Origination Form

Proposed Revisions to a Standard Plans Index

Originator:	Turley, Joshua	Index Number:	455-118
Date:	8/21/2024	Sheet Number(s):	2
E-mail:	Joshua.Turley@dot.state.fl.us	Index Title:	18" SQUARE CFRP & SS PRESTRESSED CONCRETE PILE

STRAND PATTERN

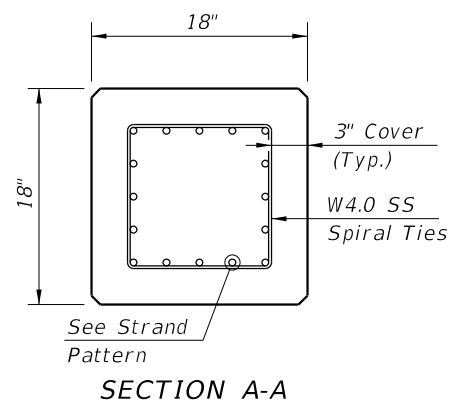
Sheet 2: Adjusted Strand Pattern diameter decimal places

16 ~ 0.52" Ø, HSSS, at 26 kips
12 ~ 0.62" Ø, HSSS, at 35 kips

This is a more accurate representation of the nominal diameter driven by the fact that the strands are fabricated in millimeters not inches.
